# CITY OF ALBANY Public Works Department

#### ADDENDUM #1

## WTP-18-01 VINE STREET WTP ACCELATOR IMPROVEMENTS

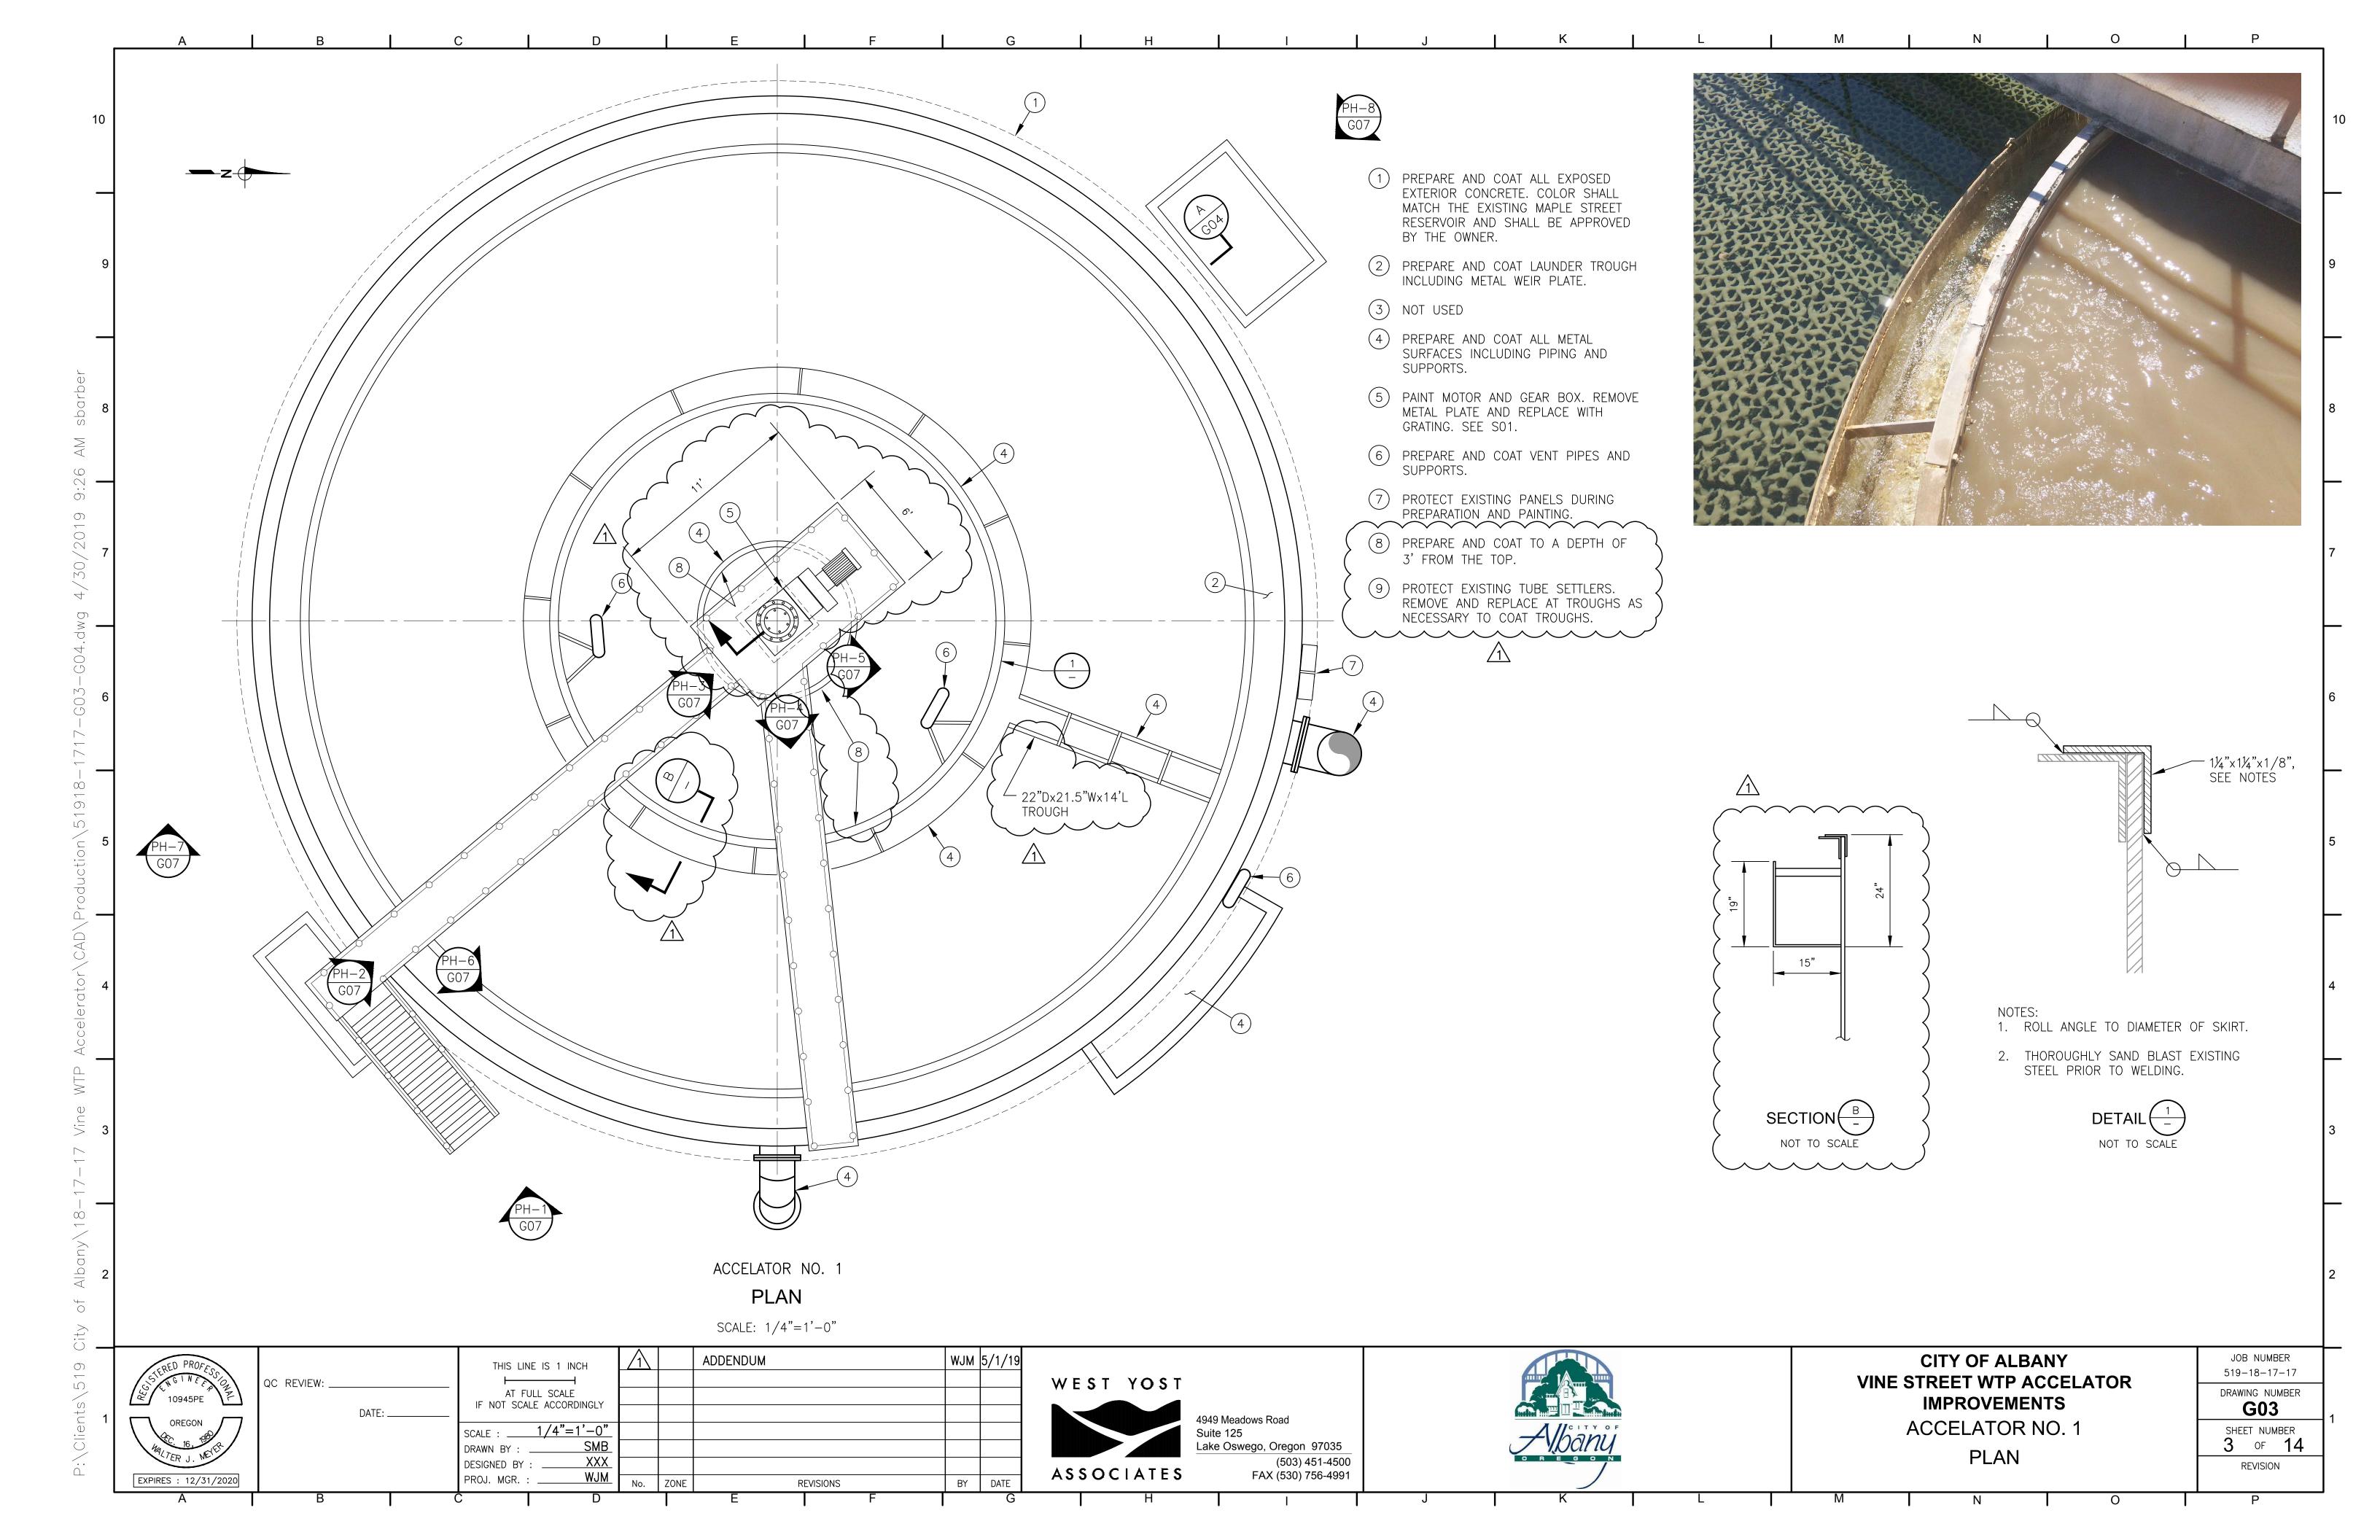
Sheet G03 was amended to clarify some dimensions.

SECTIONAL ELEVATION

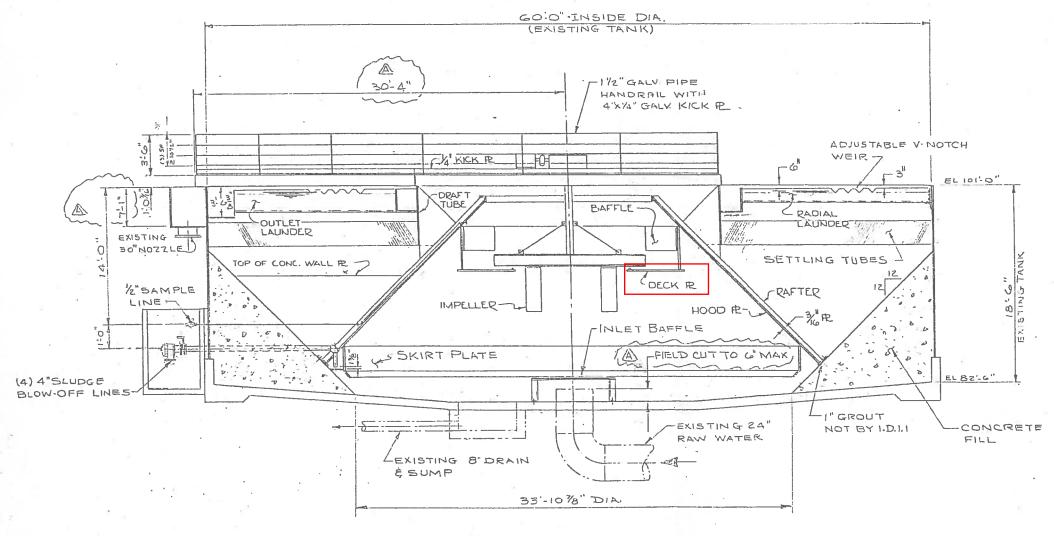
Drawing G06: The inside of the cone shall be prepared and coated. All surfaces above the deck plate as shown in the attached shop drawing 90524-02-002 shall be coated.
